### Charlotte-Mecklenburg Planning, Design, & Development

**SUBJECT:** Administrative Approval for Petition No. 2018-144 Portman Holdings

Staff supports of the request because:

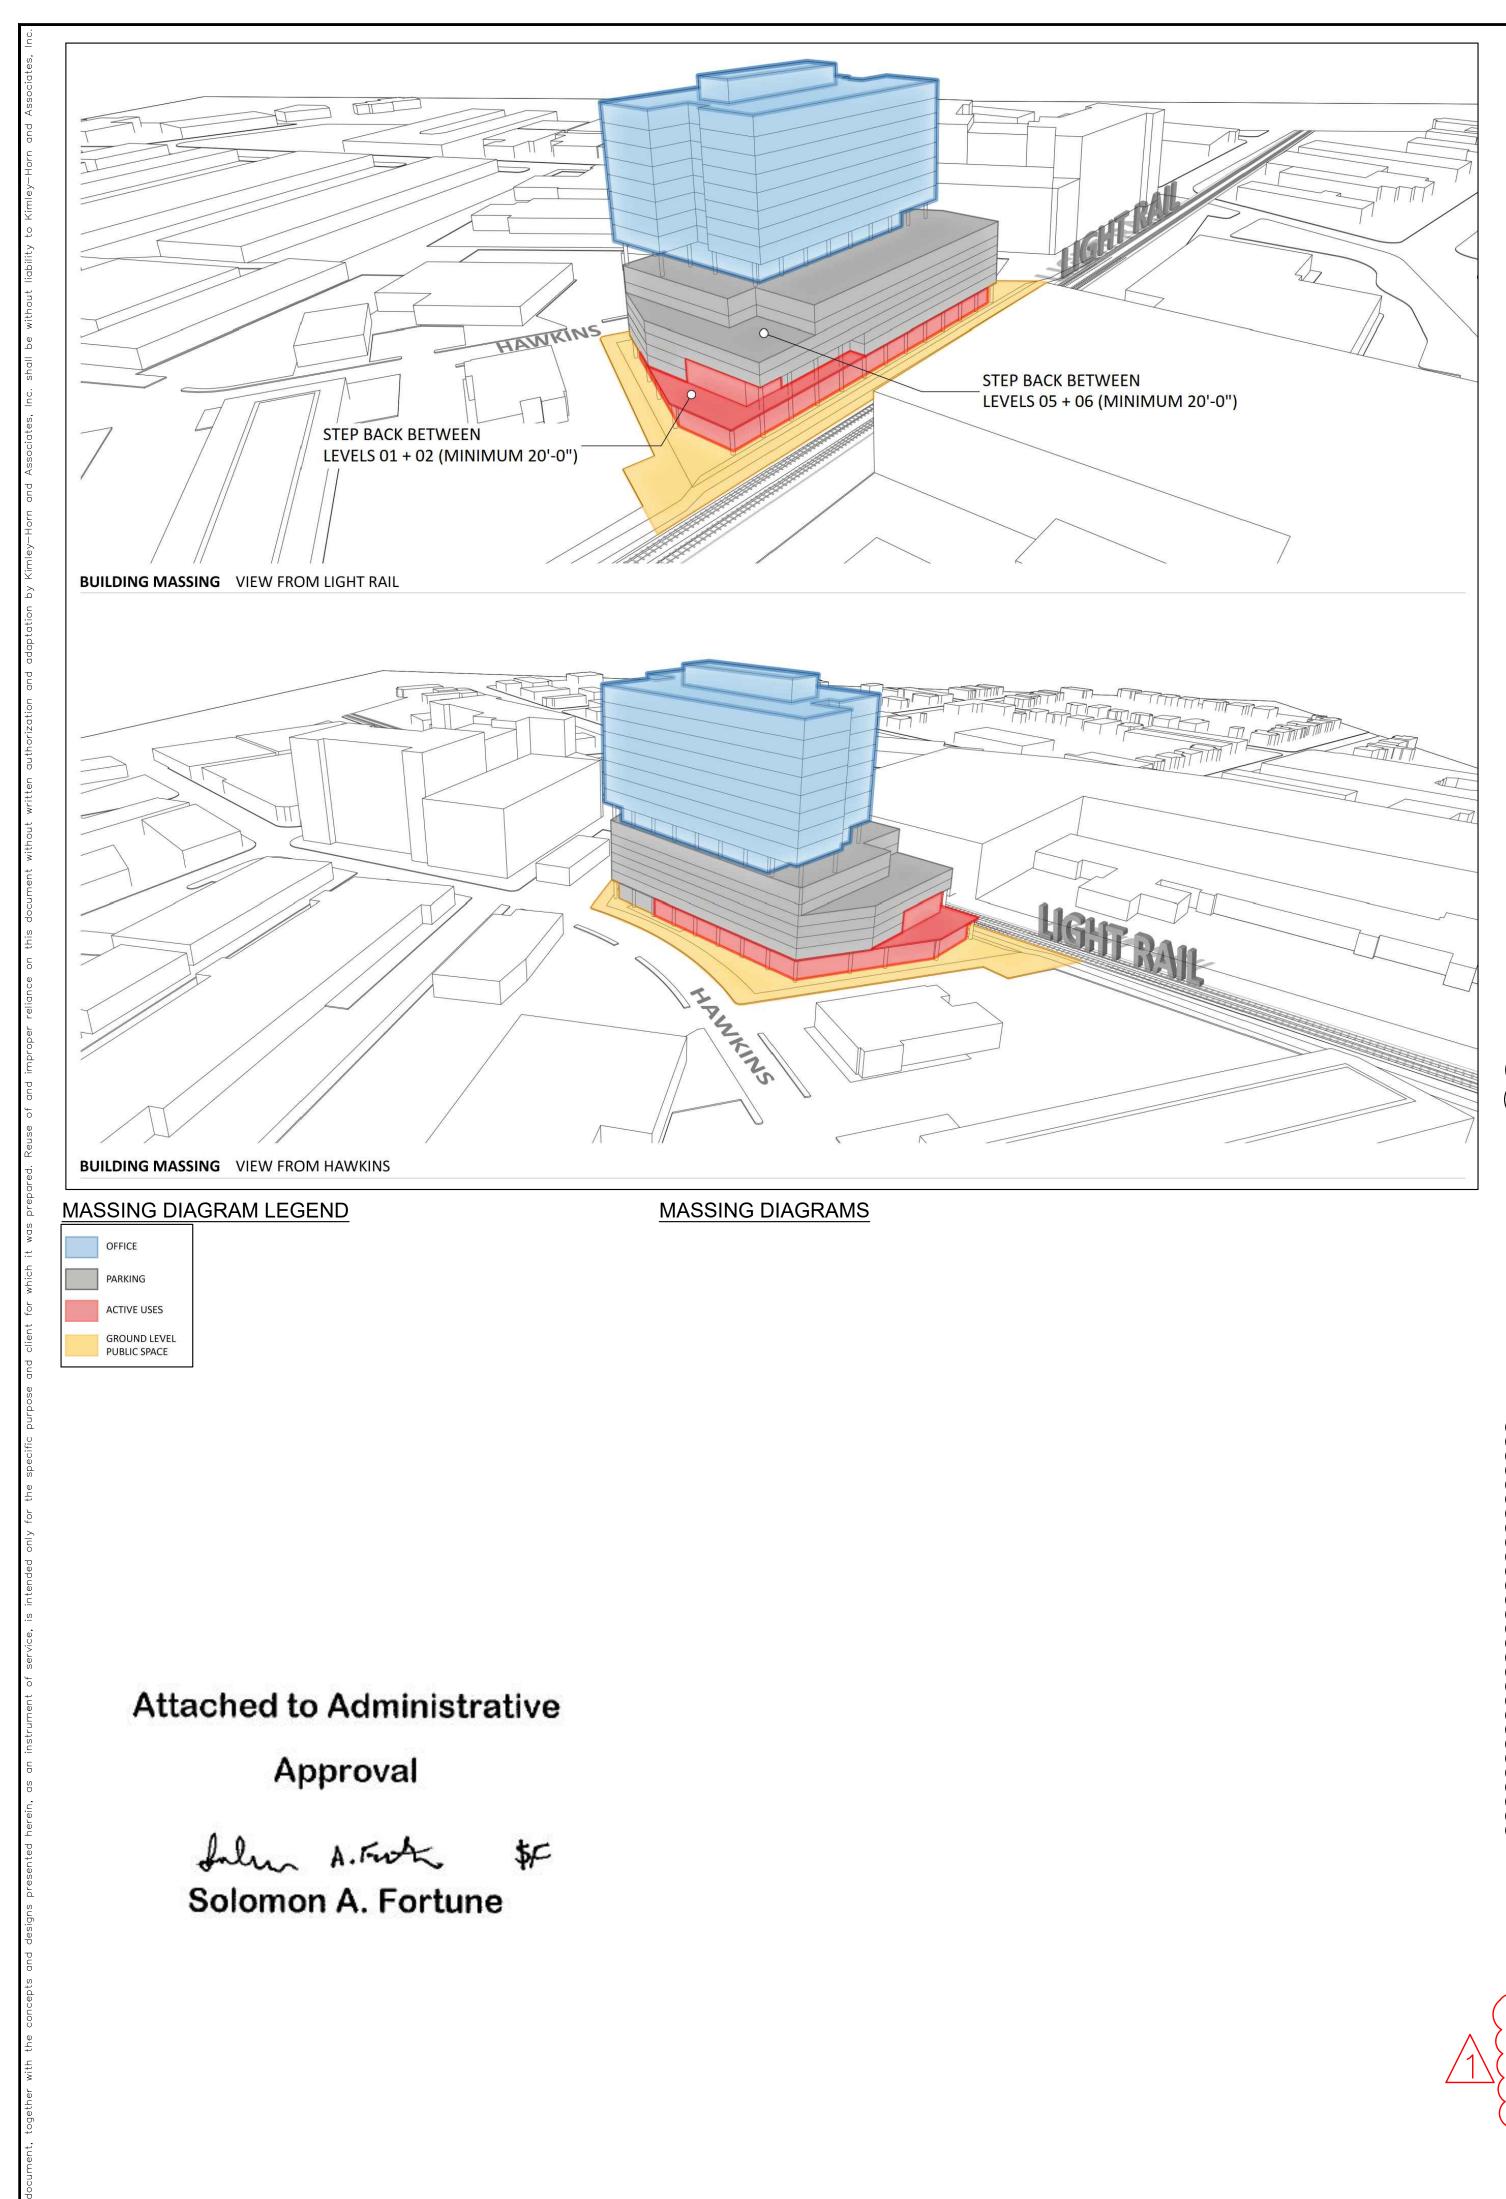
• To allow modification to the building layout on the site.

• The site plan complies with the conditional notes and still meets the intent of the original approval by the City Council.
